Exterior Signage Development  
12/7/18

THE RALPH C. WILSON, JR. CHILDREN'S MUSEUM

## Design Committee - Erie Canal Harbor Development Corporation

### **Signage Package Explore and More Children's Museum**

**EAST** View

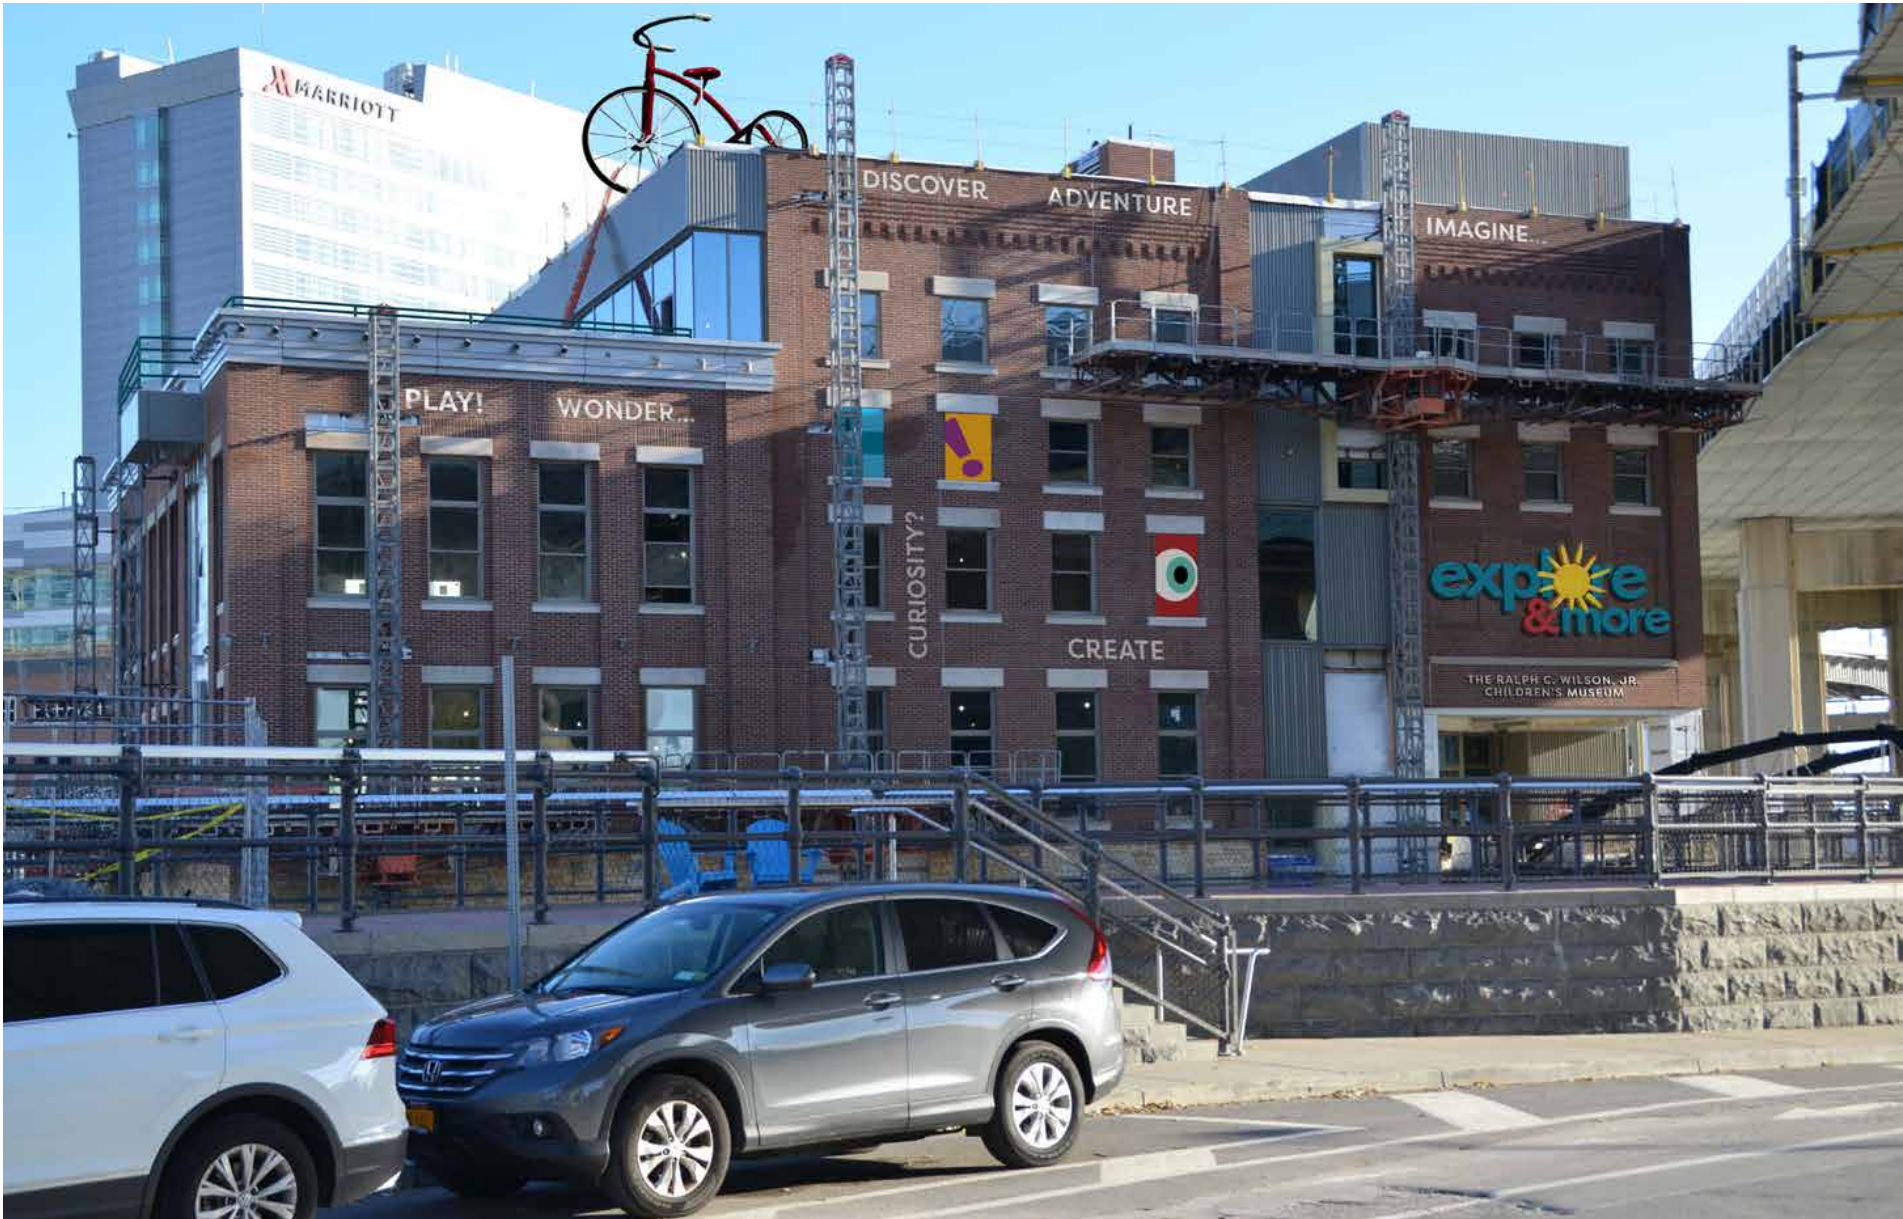
1. The rhythm of the text on the East Elevation mimics the text on the West Elevation.
2. The elimination of the 3M Brick wrap on the lintels behind the logo signage.
3. Flat cut aluminum cafe- lettering as shown on enclosed PDF.

East Entrance

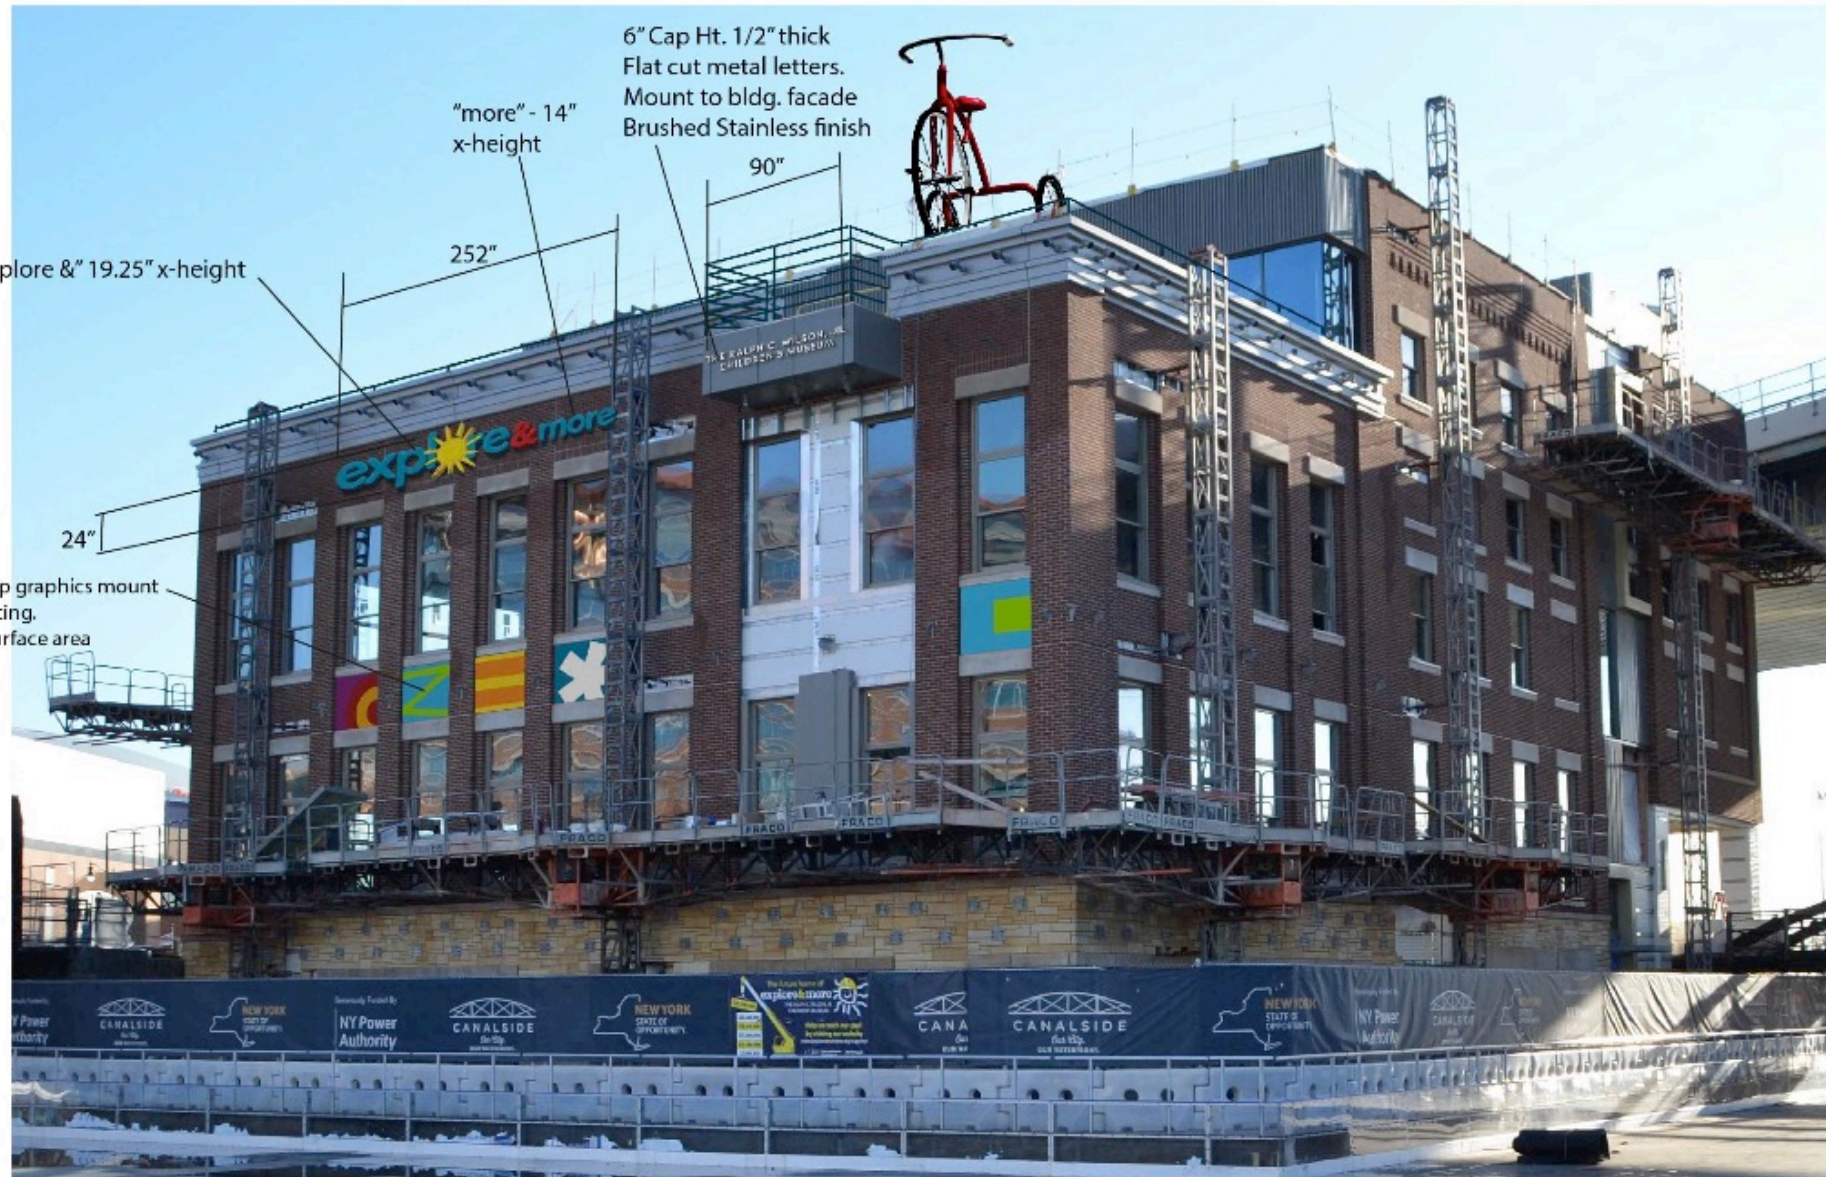
\*\*Need to discuss fabrication materials and method.

3M Brick wrap over window lintels. 53 SF area
